From: Jim Ho [jho@erscorp.us]
Sent: Wednesday, September 30, 2009 9:31 AM
To: Wickham, Jerry, Env. Health
Subject: regarding vapor wells for the Eagle Gas Station (4301 San Leandro Street, Oakland, RO096)
Attachments: vapor well diagram.pdf

Vapor Well Completion Diagram
 Vapor Wells VP-1 Through VP-6

Eagle Gas
 4301 San Leandro Street
 Oakland, California

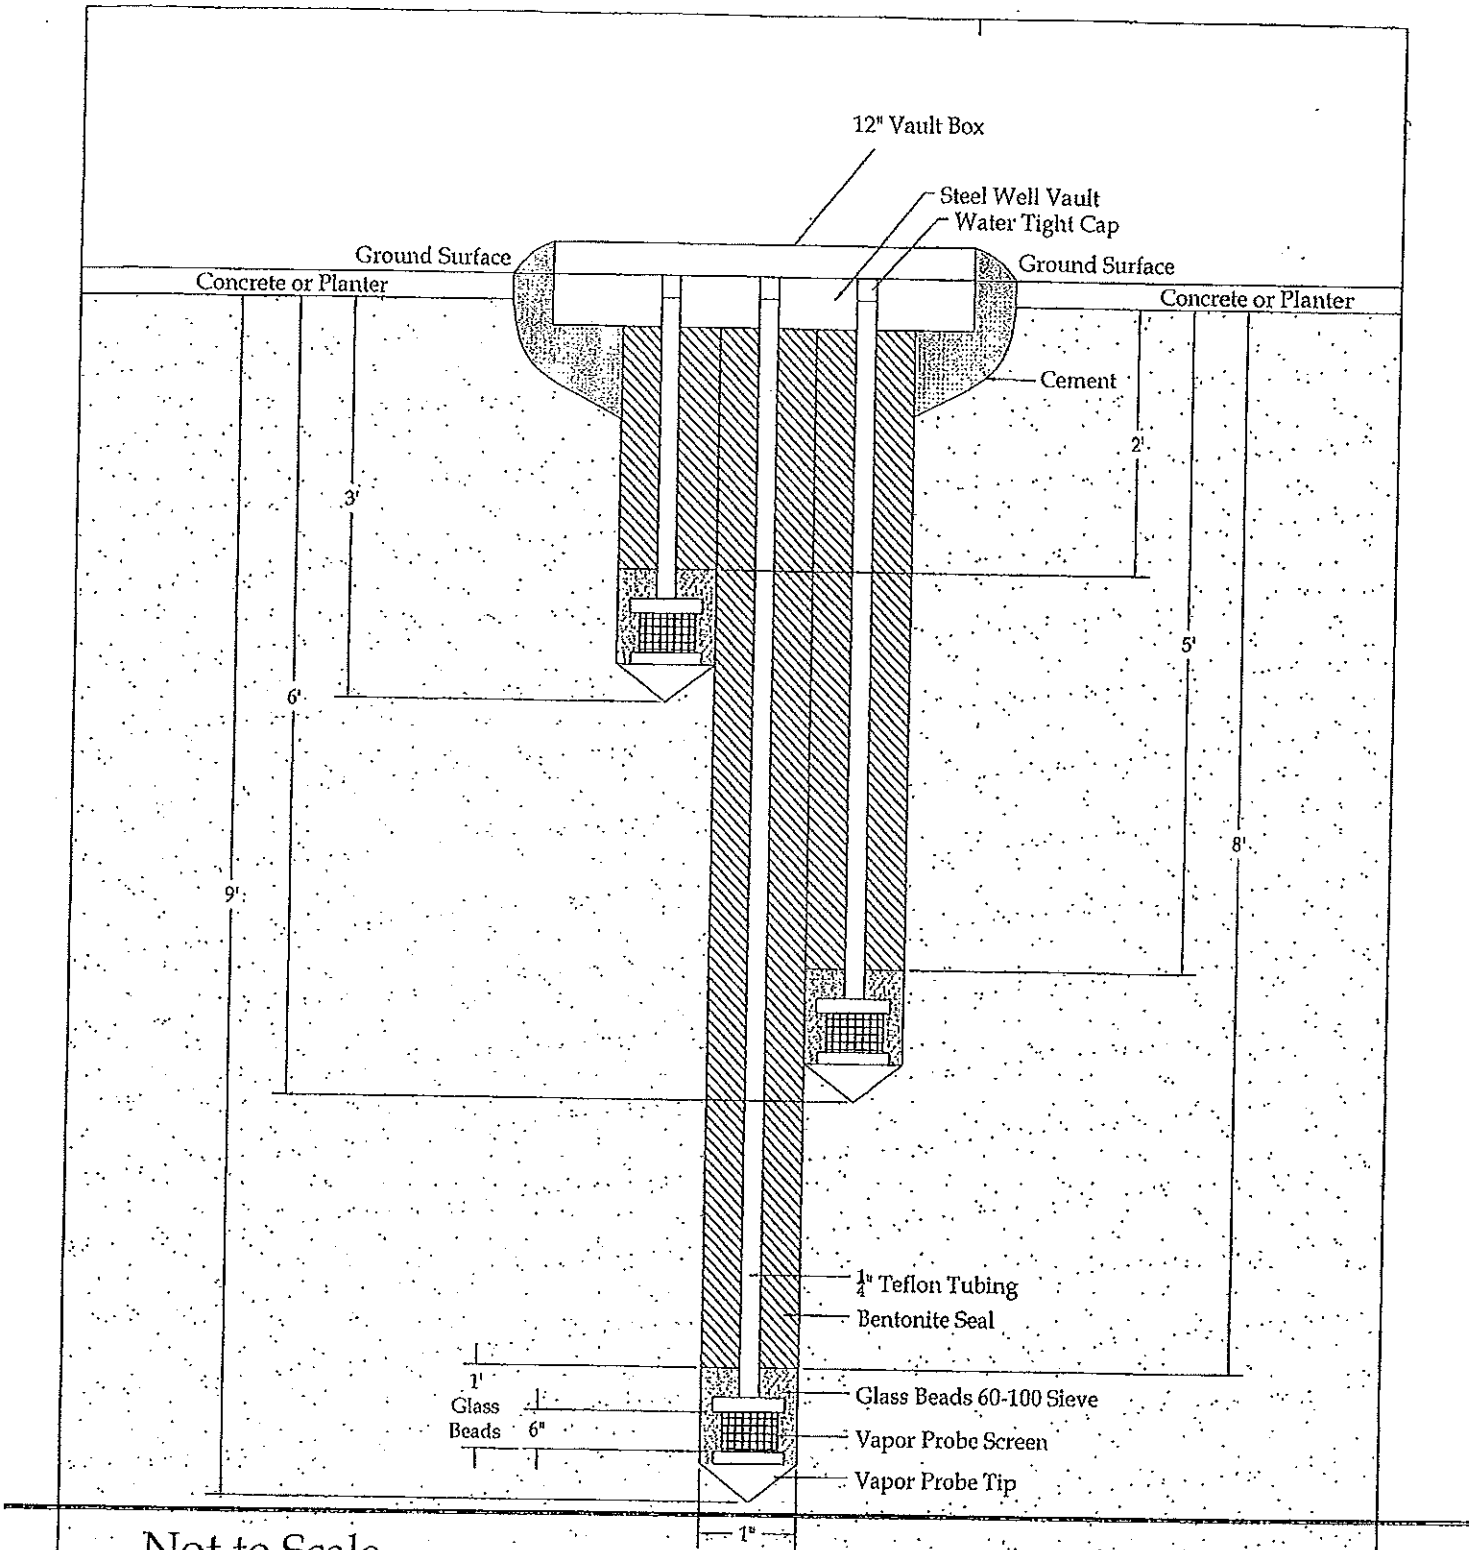
As you may know the site always has many people walking around looking for work/employers. I noticed that vapor well VP-6 located near to the east pump island is in bad shape. The lid of the well box is not only loose (without screw), the well box also stick above the ground due to sloppy well construction. People could kick around the lid for a while. This may pose an safety issue in case people trip. I also checked those three 1/4" Teflon tubing inside the box. Some are filled with dirt. I do not know the inside condition of the tubing. Since all vapor wells were primarily used to sample vapor in the vadose zone, the data had been presented by Clearwater.

Although I planned to use some of them as observation wells to measure the vacuum in the vadose zone for the DPE pilot test, based on the condition of the wells, I don't think they will be useful. Since these wells probe the vadose zone at 3, 6, and 8 feet bgs, they will be less indicative to determine the horizontal range of influence in the saturated shallow zone. In addition, since the top of screen for all the DPE wells will be at/below 8 feet bgs, clay uniformly exists in the depth interval between 0 and 5 feet bgs, and the ground is covered with asphalt/cement, the vertical leakage of vacuum will be minimal/insignificant during future vacuum extraction.

Based on the above conditions, I propose to abandon all vapor wells. You know the site has only limited space. Unfortunately, 23 groundwater monitoring wells have been installed on the property, in addition to 6 vapor wells. Thus, I will propose to abandon some of the monitoring wells in the future after the data of the Interim Remedial Action/Pilot Test are available. If you have any comments regarding the abandonment of vapor wells, please let me know as soon as possible. Thanks a lot.
